TO: Design Review Commission

FROM: David Kornfield, Planning Services Manager

SUBJECT: 14-SC-43 – 582 Glen Alto Drive

14-SC-43—582 Glen Alto Drive

SITE PLAN

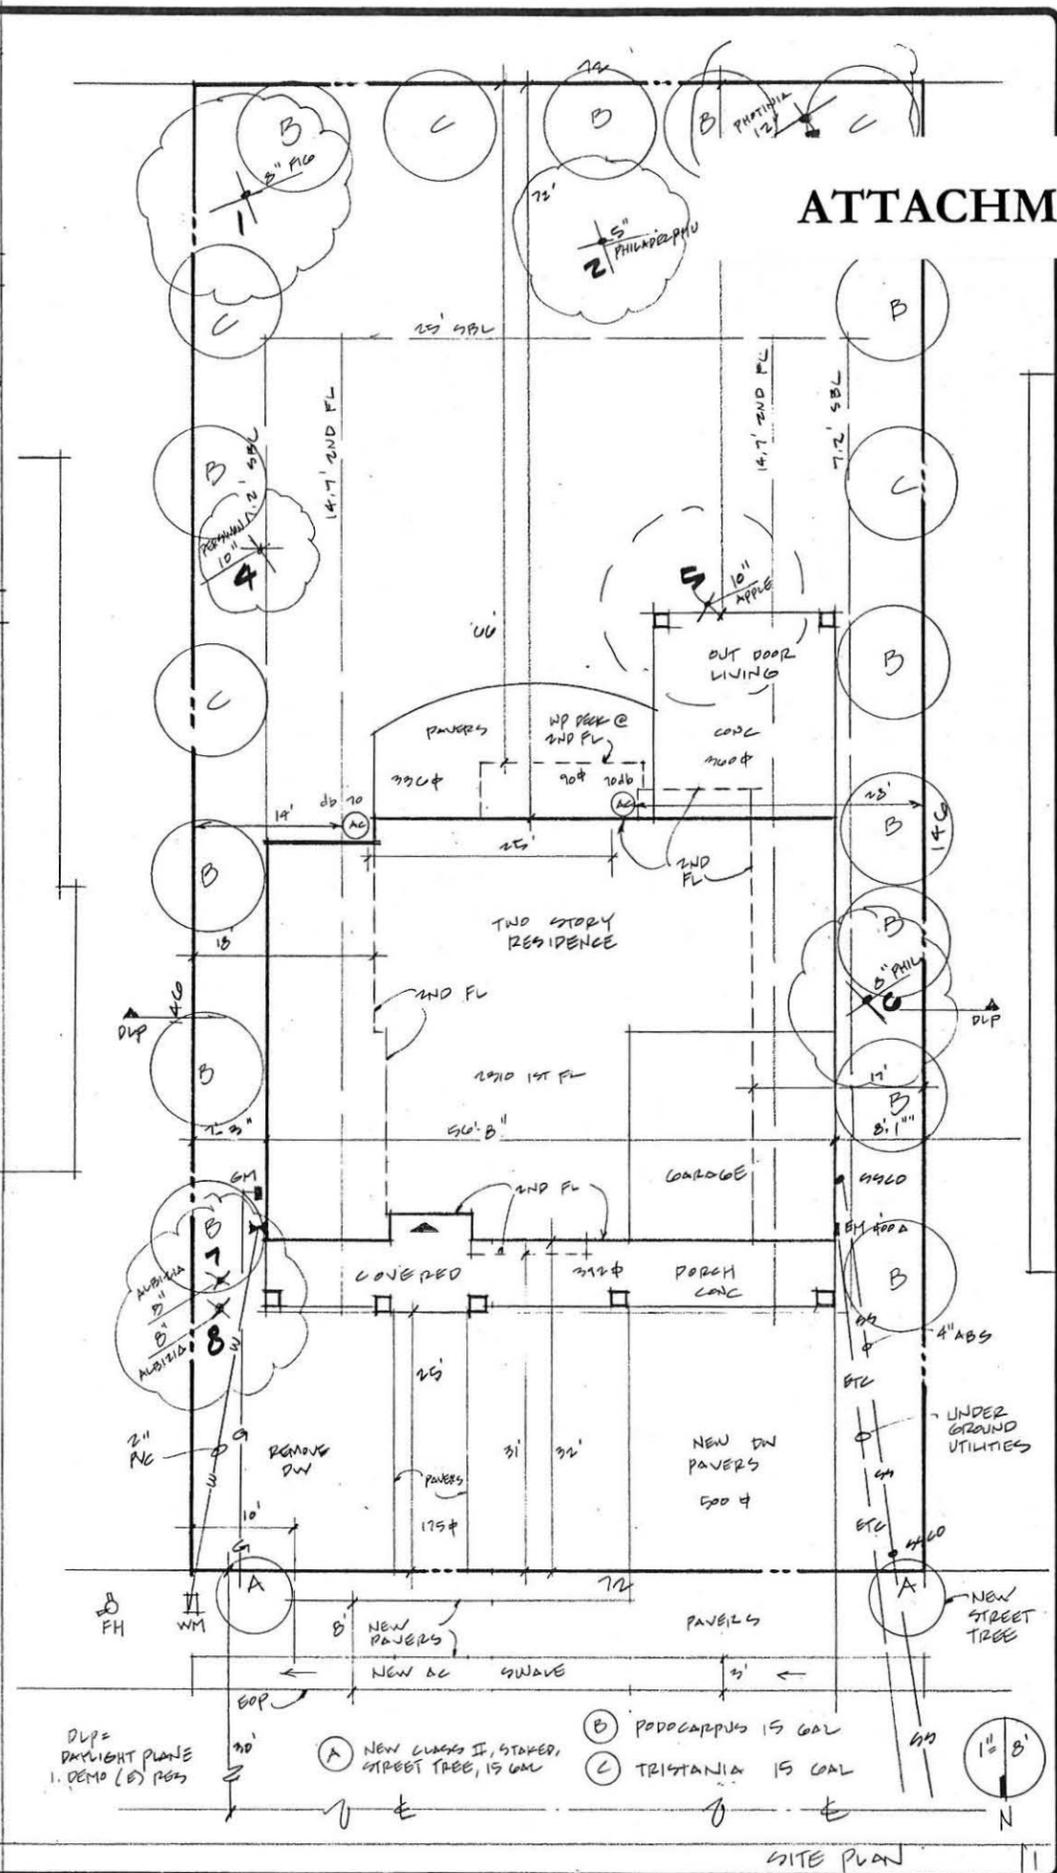
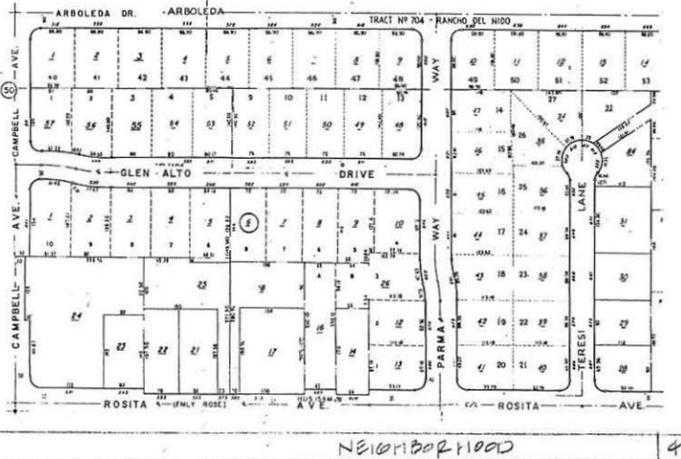
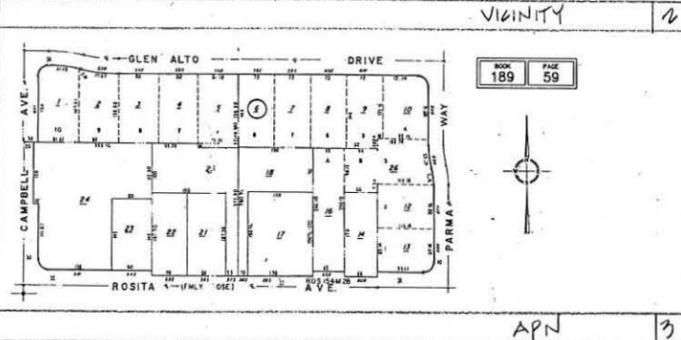
In the process of changes the house moved towards the rear of the lot by three feet. This still has a negative impact on our light and views of the sky and distant tree tops. Moving it forward three feet to where it had been planned would remedy this and would also be better for both our and the new homeowners' privacy.

Another area of concern is the placement of two air conditioners on the side of the lot facing us, where there had not been any on the prior plan. We are very worried about the noise they will generate. Their fans will never run at the same speed and this will create a "sing-song" (e.g., an irritating modulation of sound). We like to open our windows for fresh air, especially during the summer, and would like peace and quiet. We ask that at a minimum the one towards the rear of the house be moved farther away from us.

RIGHT ELEVATION

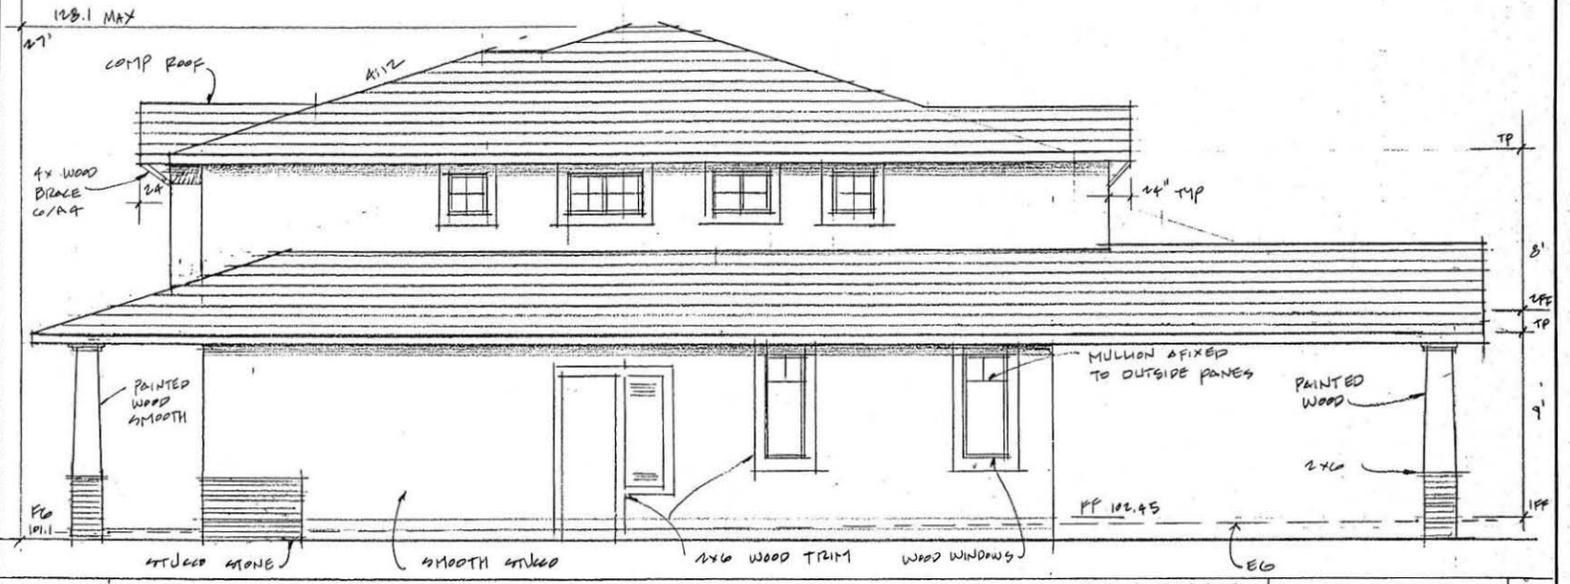
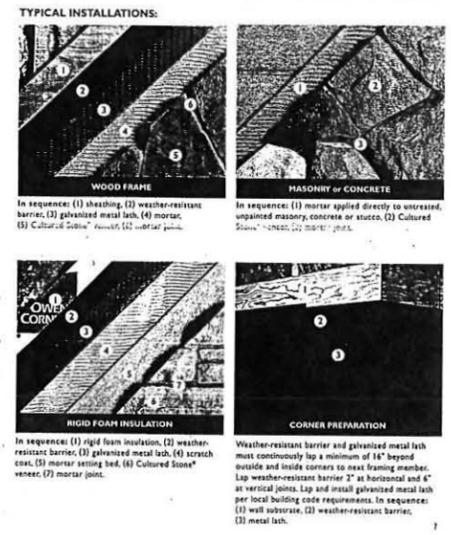
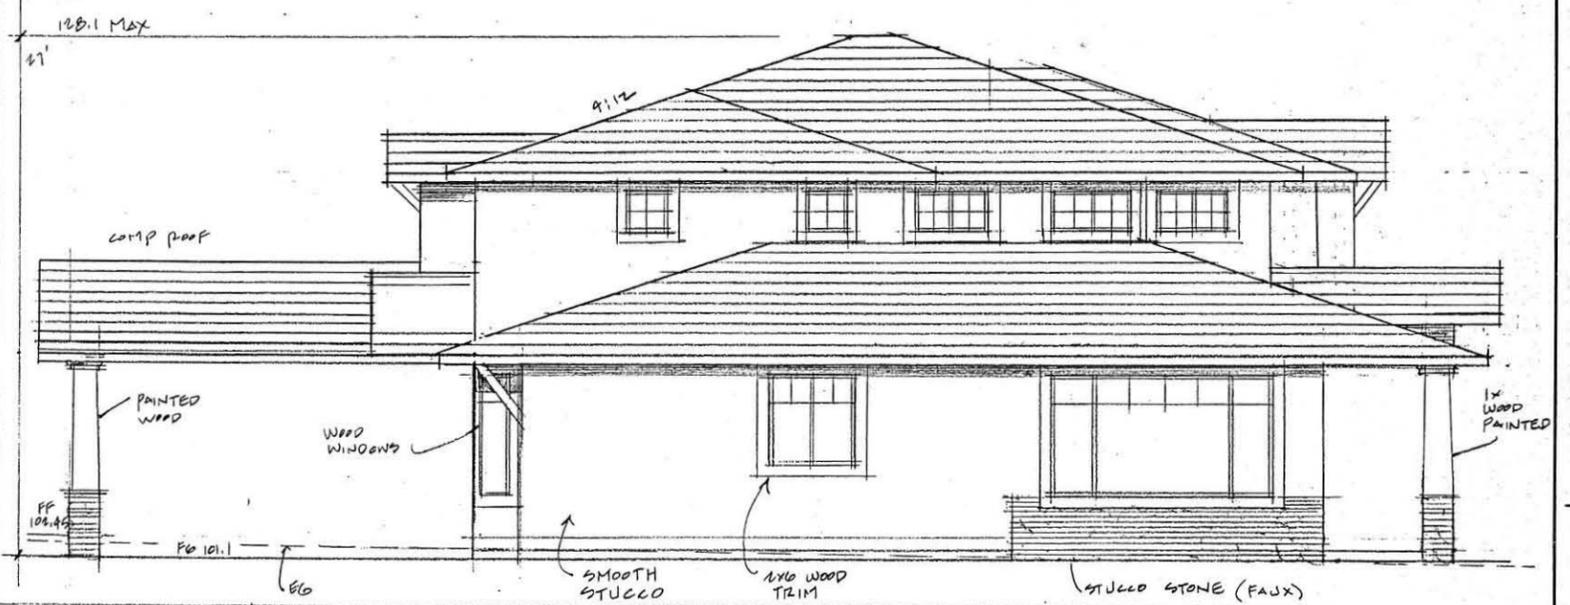
Although the left side of the second story has five windows, three of them are in a clearstory element and the others are in a closet or bathroom.
